Engineering Change Notice

The following table contains a list of engineering changes that are not reflected in the Tsi381 Evaluation Board Schematics.

Table 1: ECN for E2000_AS001_05 (Board order number Tsi381-RDK1 V2.0)

Tsi381 Evaluation Board Schematic

TITLE : Tsi381 PCIE/MISC			
SIZE C	DRAWING NUMBER : 60E2000_SCO01_03	Version: 1.0	DESIGNER :
LAST MODIFIED DATE : 7-24-2007_17:09		SHEET 3 OF 15

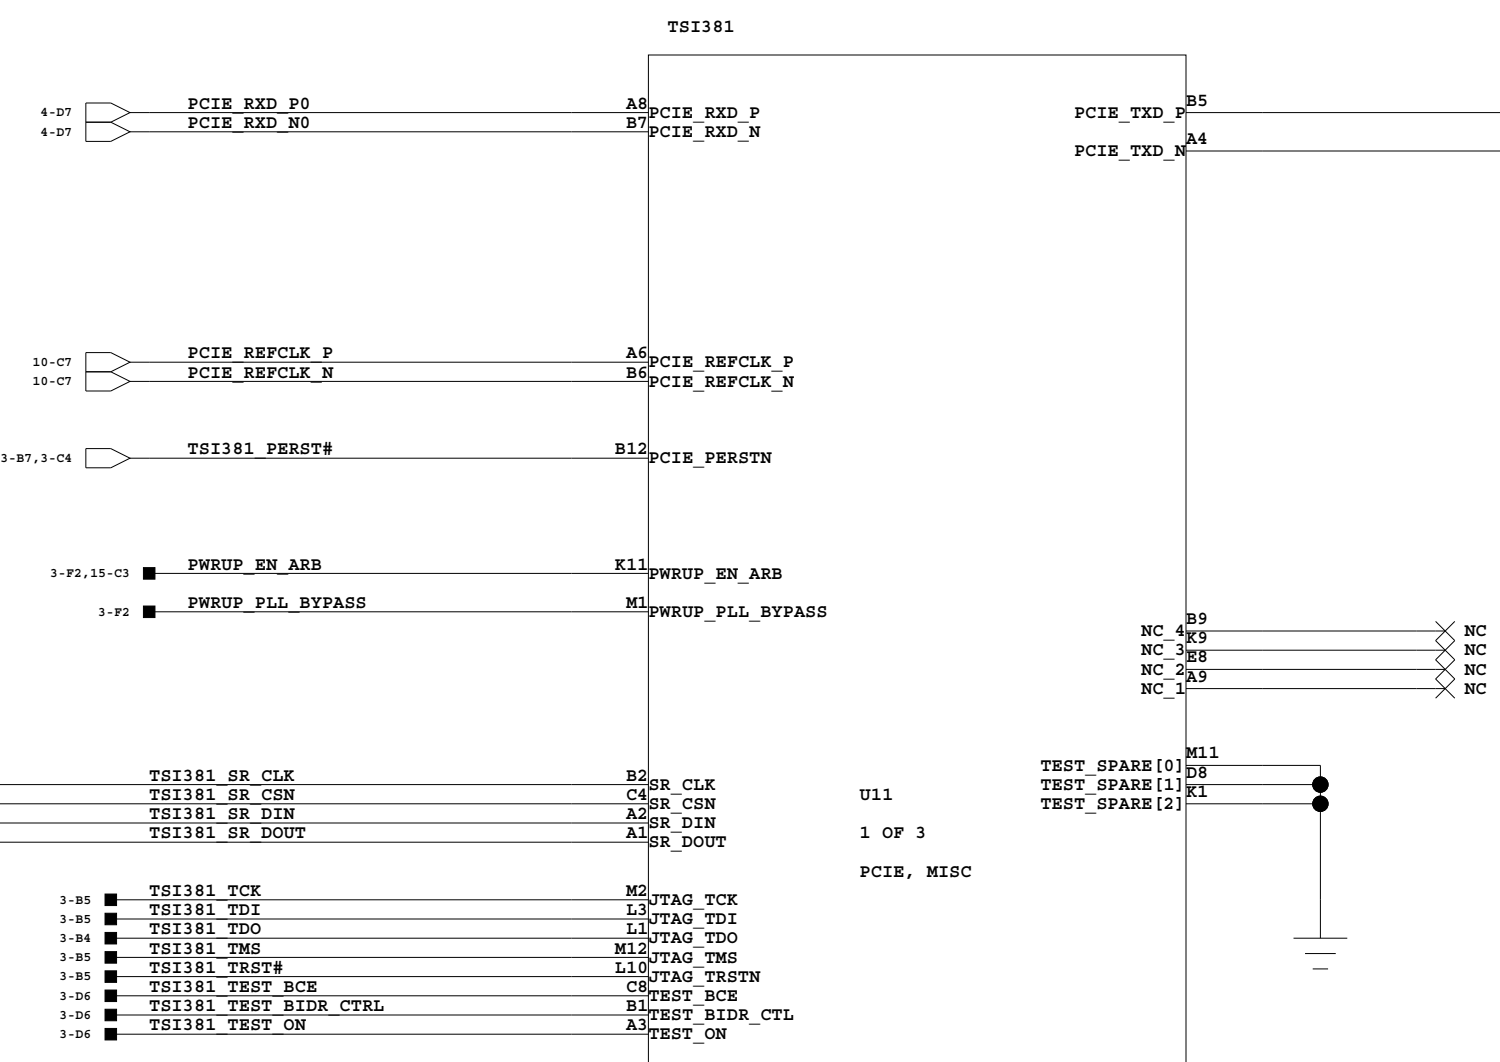
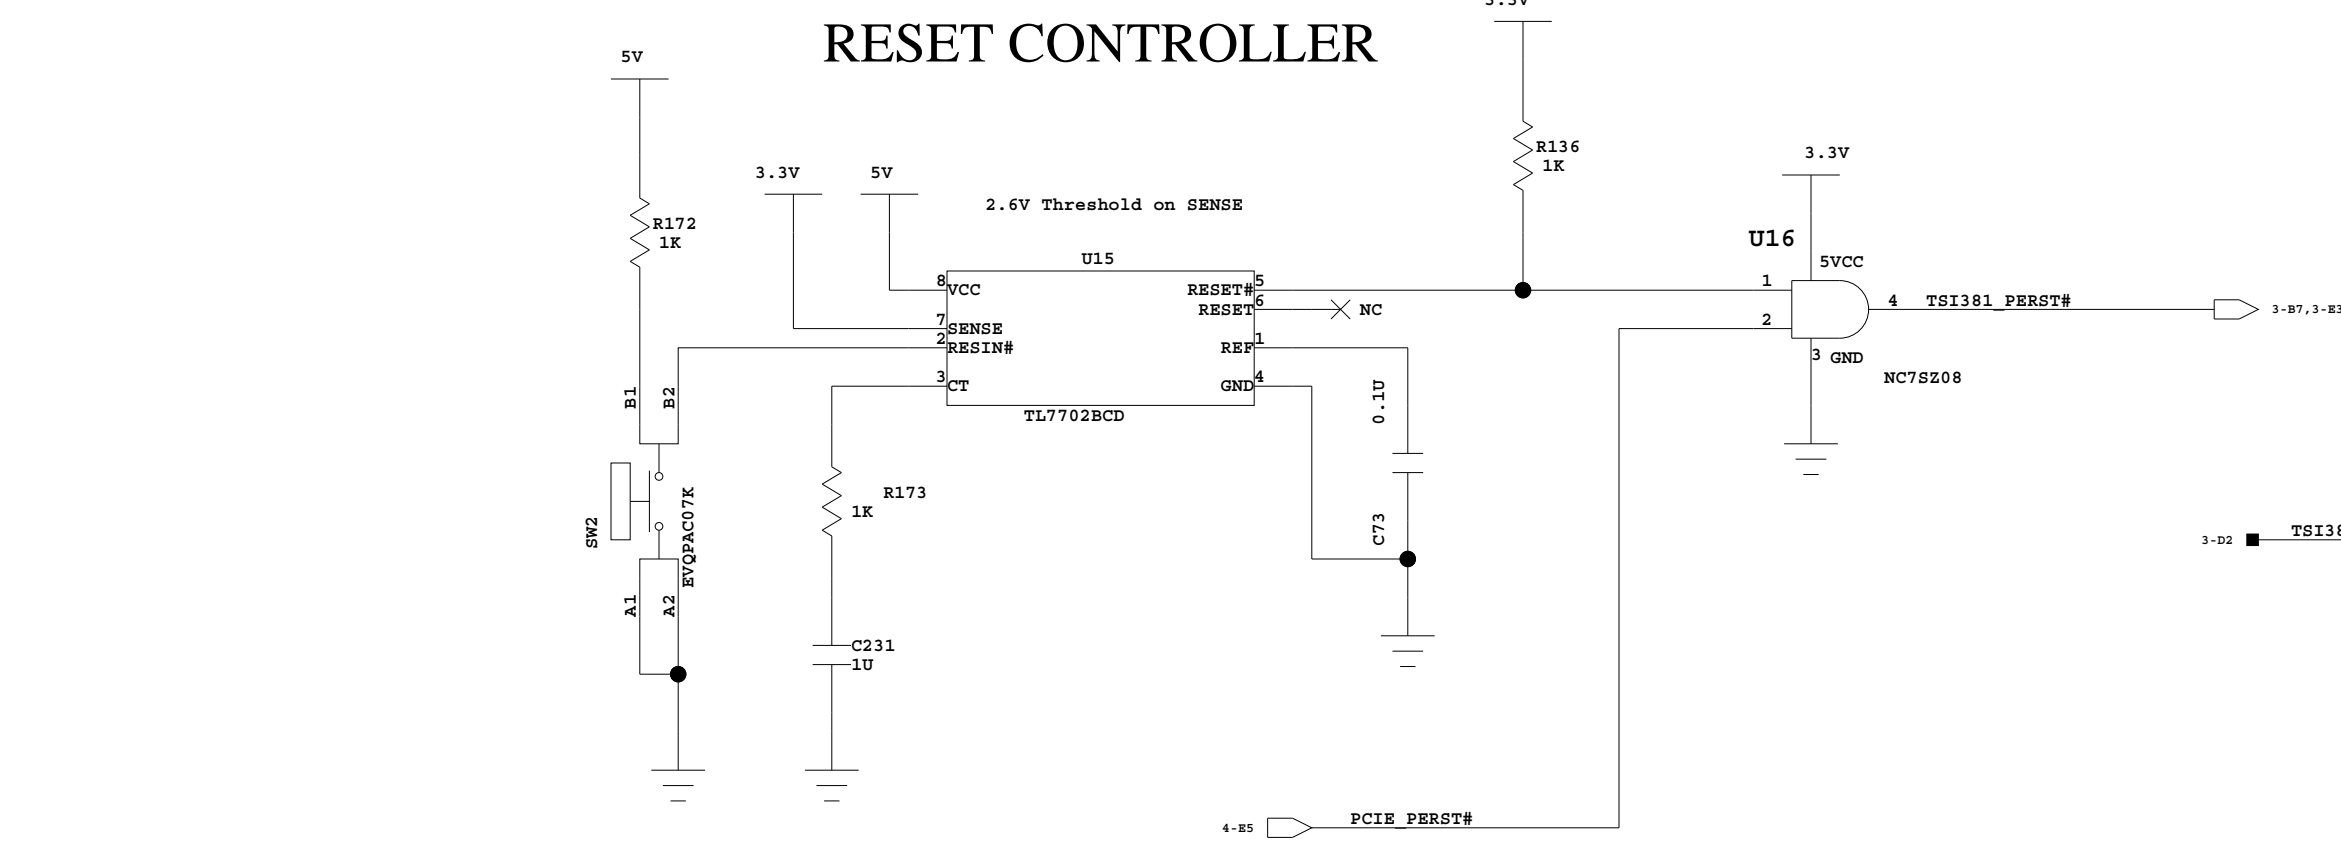
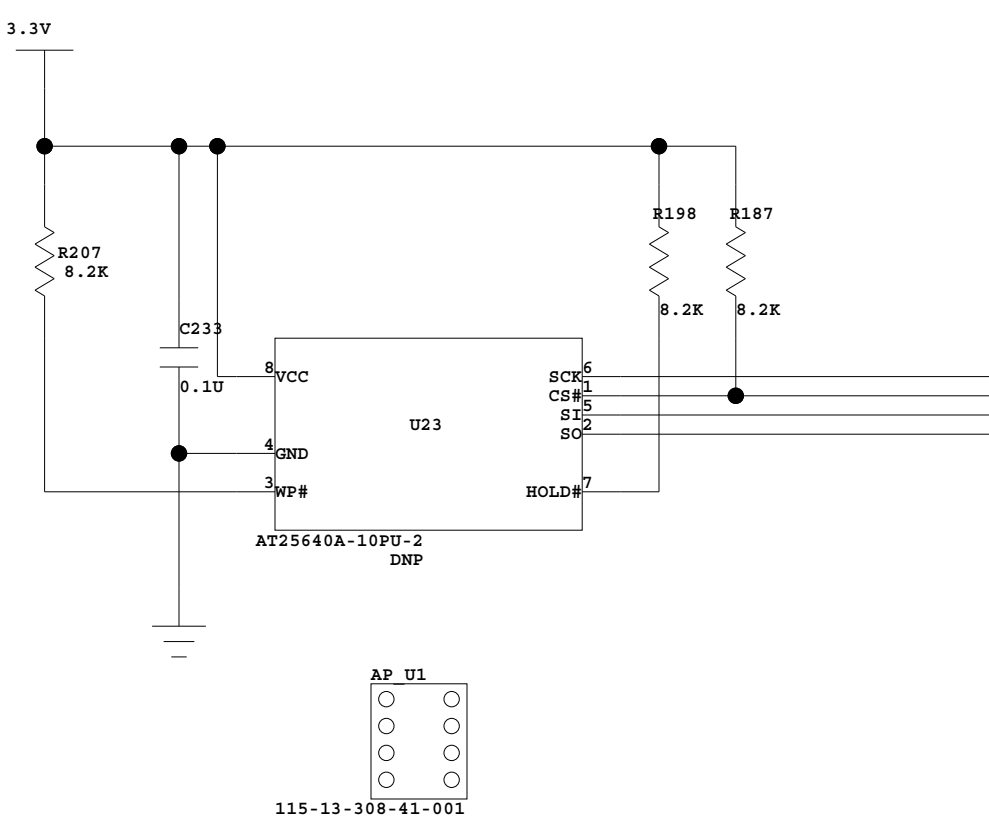
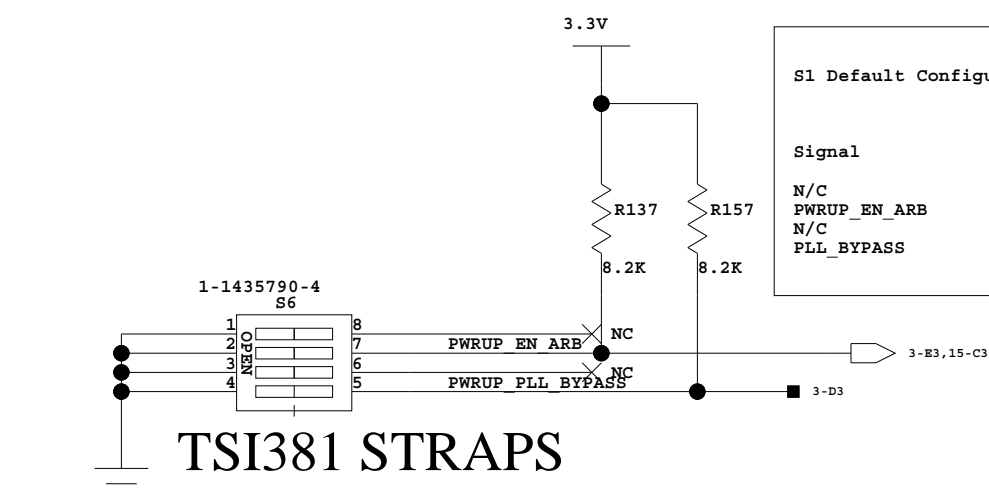
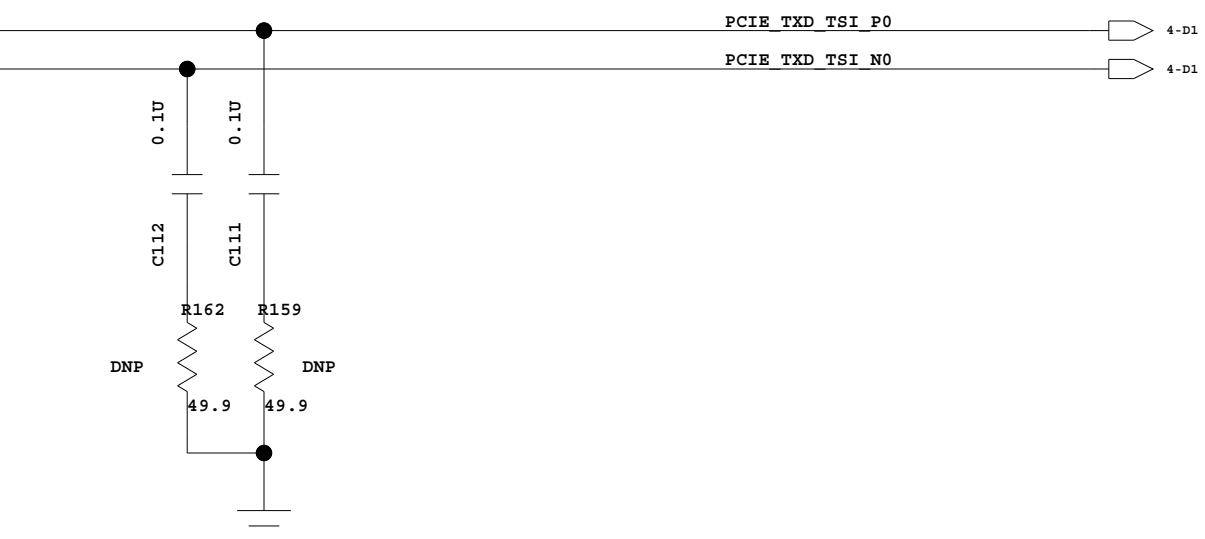
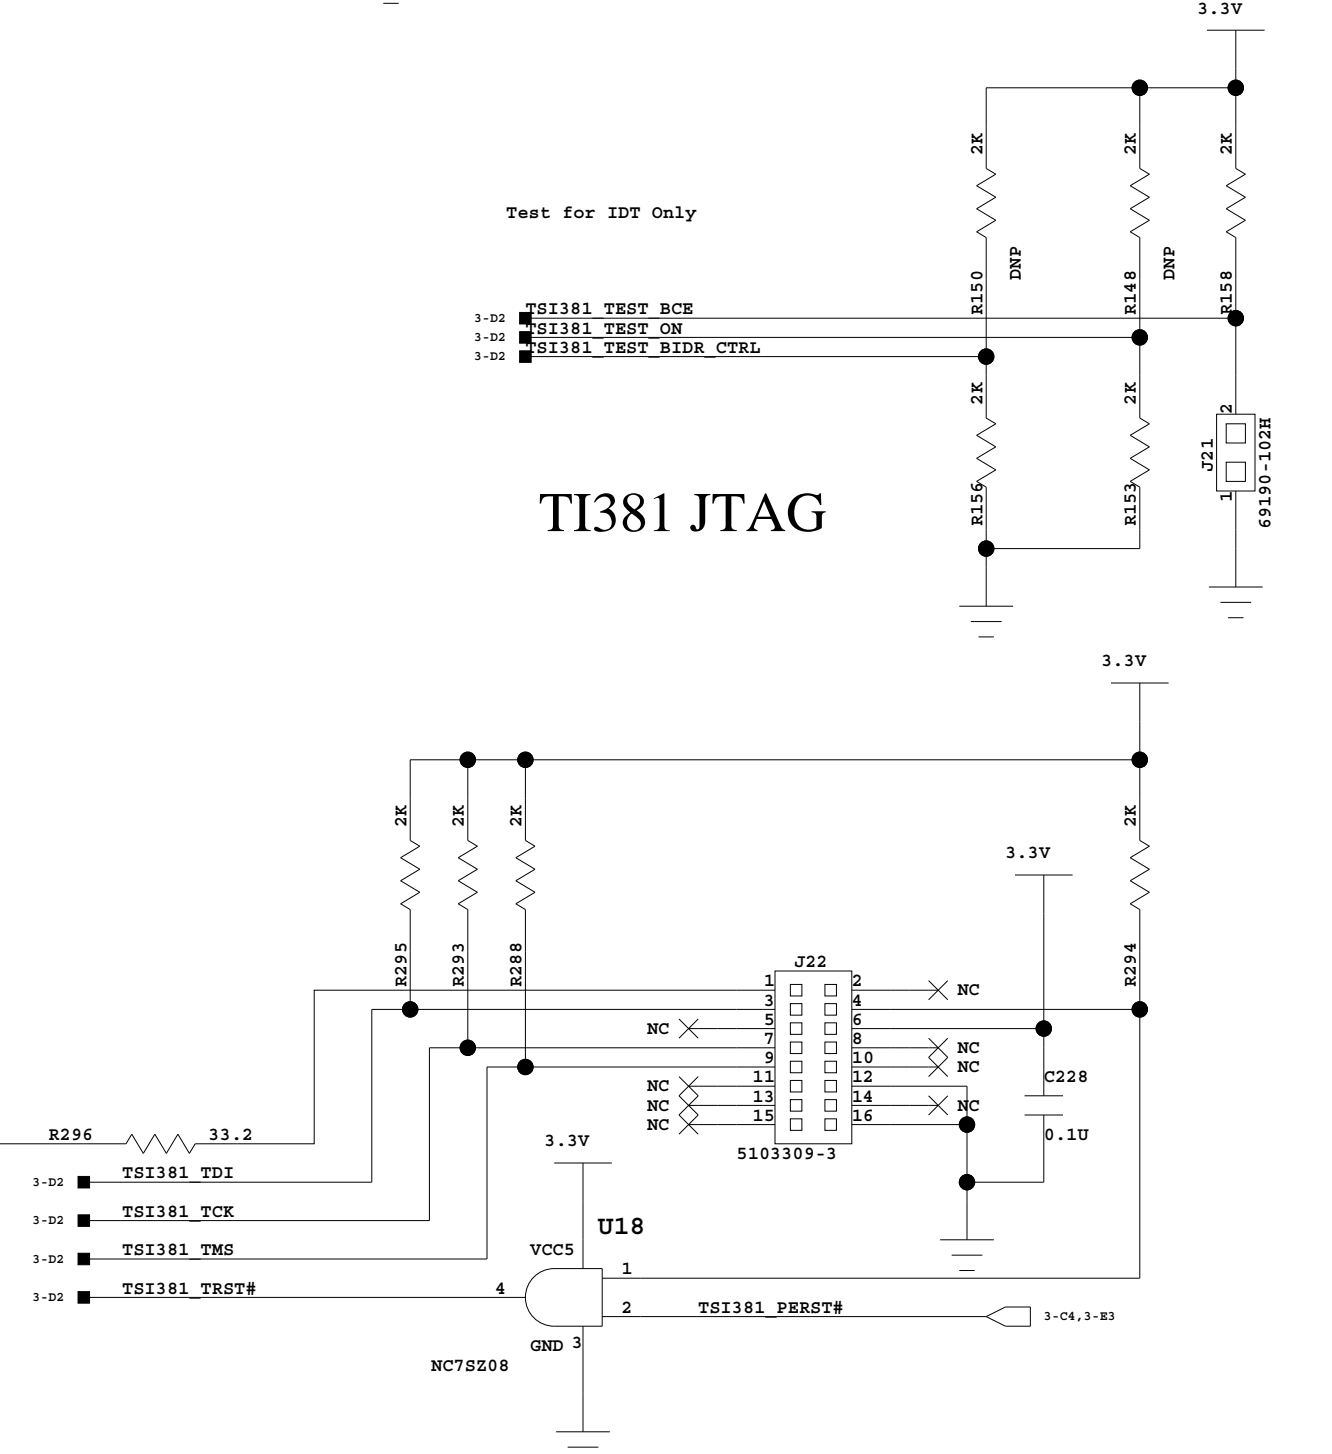
No.	Item(s)	Original	Change To
1	Tsi381 Device	Tsi381-66ILZ1	Tsi381-66ILZ2
2	3.3Vaux on J1, J2, J36, J37 ^a	No connection	Short pin A14 (3.3Vaux) to pin A16 (VIO_PCI) with 0-Ohm (0603) resistor

No.	Item(s)	Original	Change To
1	Tsi381 Device	Tsi381-66ILZ1	Tsi381-66ILZ2 ^a
2	3.3Vaux on J1, J2, J36, J37 ^b	No connection	Short pin A14 (3.3Vaux) to pin A16 (VIO_PCI) with 0-Ohm (0603) resistor

a. Ball K1 was removed from the Tsi381 device to allow the TEST_SPARE[2] signal to be detected as logic high. This version of the evaluation board is intended to support applications that require PCI bus parking on the Tsi381.
